# **First Five-Year Review Report**

## **Motor Wheel Disposal Site**

**Lansing, Ingham County, Michigan**

### **COMMENTS RECEIVED FROM SUPPORT AGENCY**

ZONE 3  
CAPTURE ANALYSIS  
JANUARY 22-23, 2002

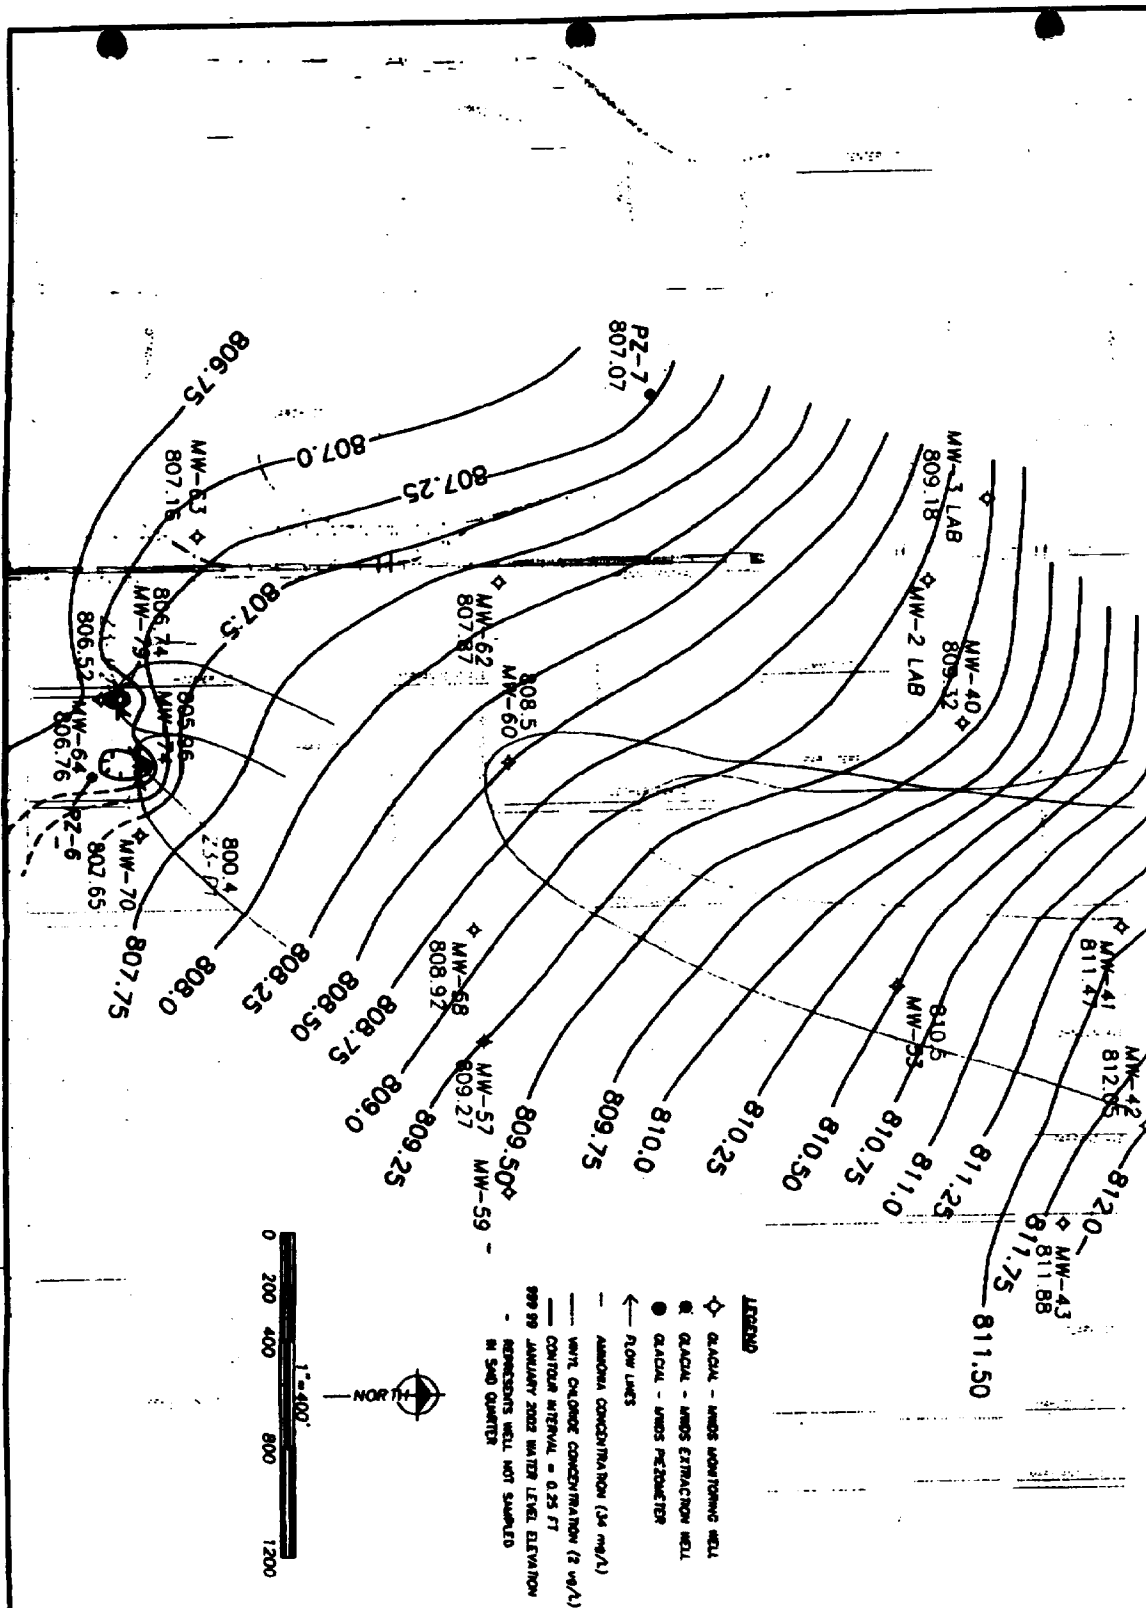
Figure 3C. The one piezometer installed in this zone, PZ-6, is too far to the east to provide useful data regarding the hydraulics downgradient of the extraction wells. There is no way to demonstrate chemical capture in this zone (no bypass) due to lack of useful monitoring wells; the demonstration of hydraulic capture has always been a problem for this reason.

Figure 3C. Contouring in Zone 3 is simply impossible. Only three data points were collected, only one of which is in proximity to an extraction well. The other two data points were located east and west of the pumping zone: over 600 and 250 feet respectively. Hydraulic capture is unlikely and cannot be demonstrated, and the text should point this out instead of stating that hydraulic capture is better than in the previous quarter (November 2000). Without data, there is no possible way to demonstrate capture. The one piezometer installed in this zone, PZ-6, is too far to the east to provide useful data regarding the hydraulics downgradient of the extraction wells. There is no way to demonstrate chemical capture in this zone (no breakthrough), and the demonstration of hydraulic capture has always been a problem.

Figure 4 - MWDS Vinyl Chloride Averaged Concentration (By Zone) vs. Time  
April 1998 Through March 2002

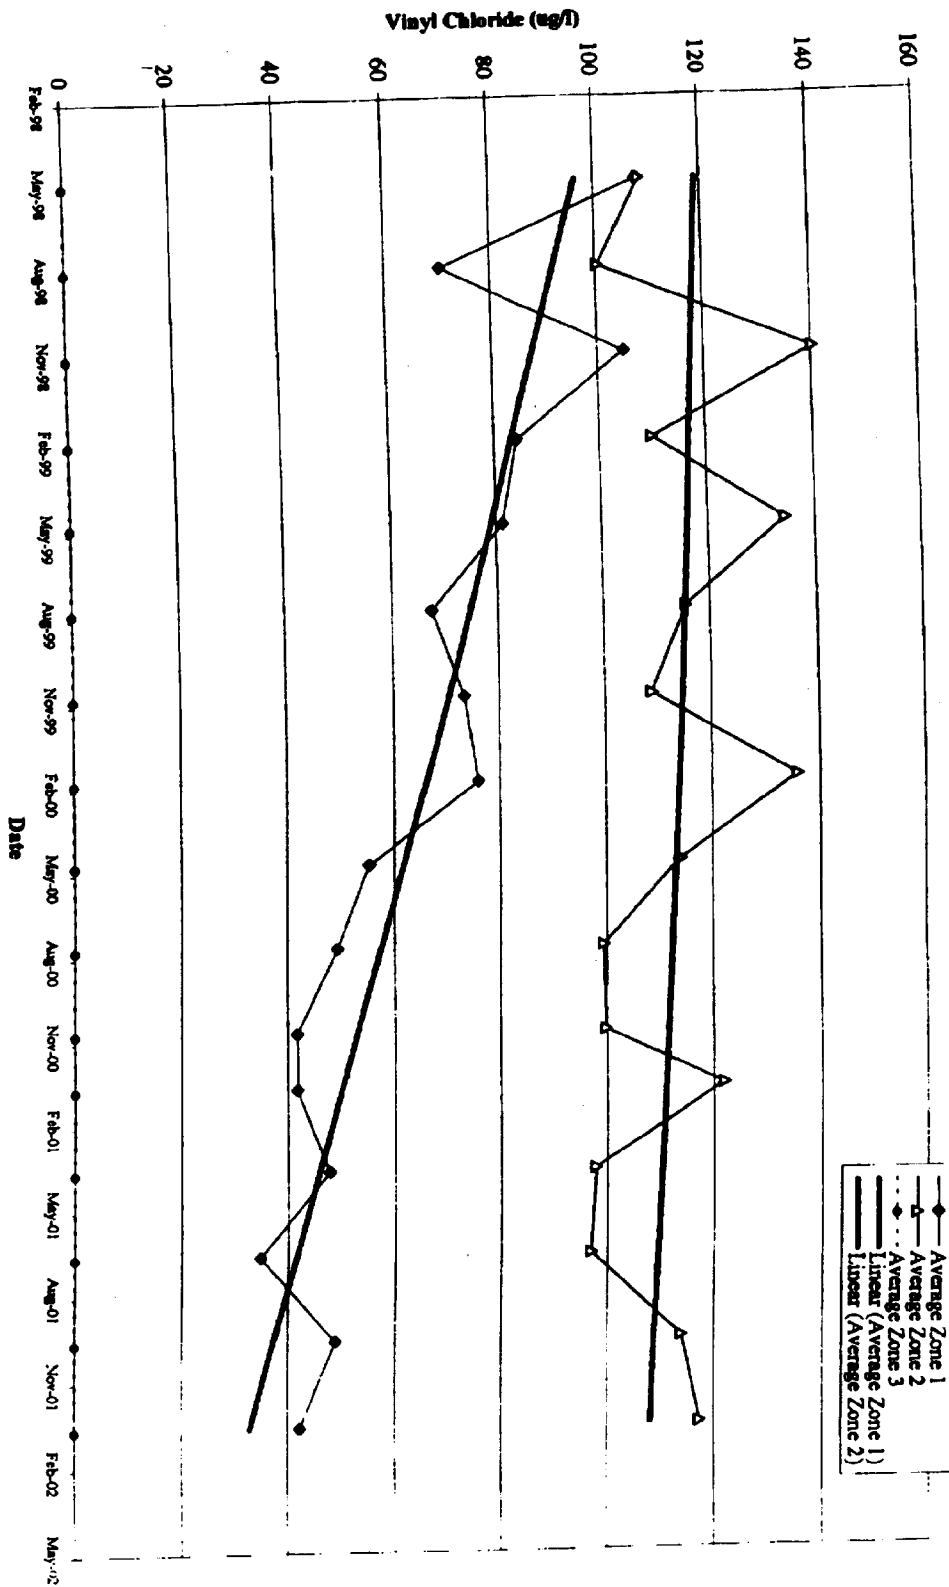
First paragraph. The text notes that the vinyl chloride concentrations peaked in April of 1998. However, Figure 4 graphically illustrates these data and May is denoted as the month of peak vinyl chloride concentrations. The text and figure should correlate.

Figure 17. Ammonia Trends Remaining BWL Wells  
Through First Quarter 2002

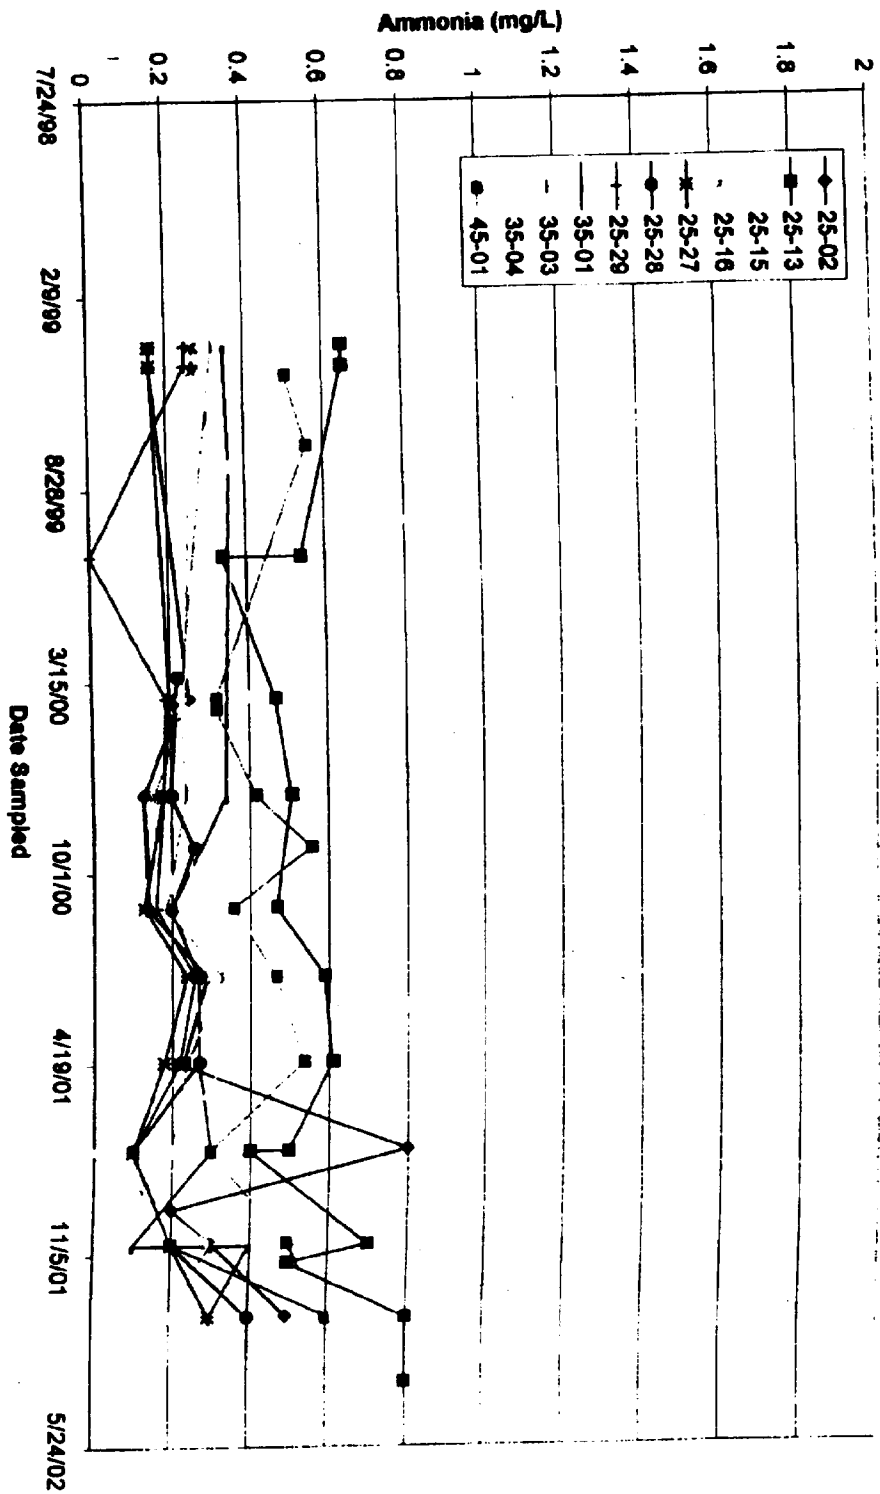
Page 16, top paragraph. As just noted above, several BWL wells have shown increasing trends in the past 3 to 4 sampling events. These trends can be seen in Figure 17 as well.
